EDMS NO. 1973028	REV. 0.2	VALIDITY DRAFT
----------------------------	--------------------	--------------------------

REFERENCE
LHC-TC-EC-0013

ENGINEERING CHANGE REQUEST

Installation in IR7 of Dispersion Suppressor Collimators (TCLD)

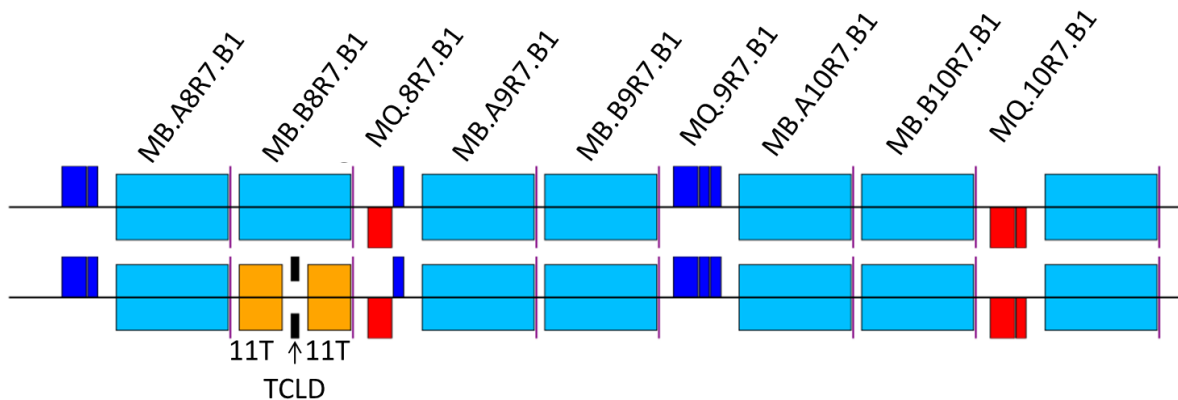
Simulations and present knowledge of the quench limits of the standard dipoles as well as the 11 T magnets have shown that the preferred placement of the TCLD is in cell 8 (on the right side of IR7 for B1 and left side for B2) [8]. The standard dipoles to be replaced by the assembly of two 11T magnets are MB.B8R7 and MB.B8L7. The schematic layouts of the present and post-LS2 IR7 dispersion suppressor on the left side of IR7 are shown in Figure 1.

Figure 2 - Positions of new TCLD collimators in IR7. Figure taken from Ref. [12].

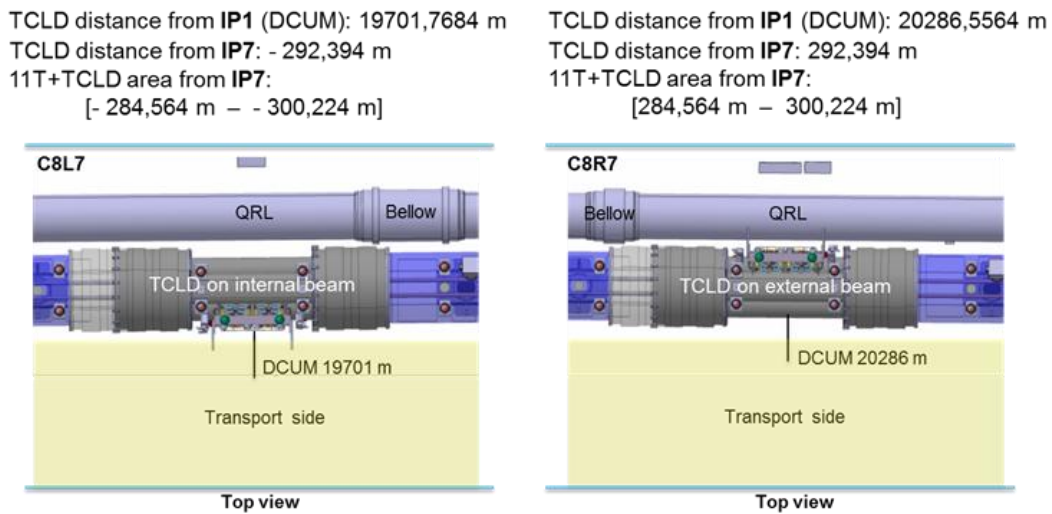
The integration and positions (DCUM) of the two TCLDs are shown in the drawings in Figure 2. More details on the integration are presented in [12], although this document (version from March 2018) will be updated in September 2018 with the very latest design and installation additions.
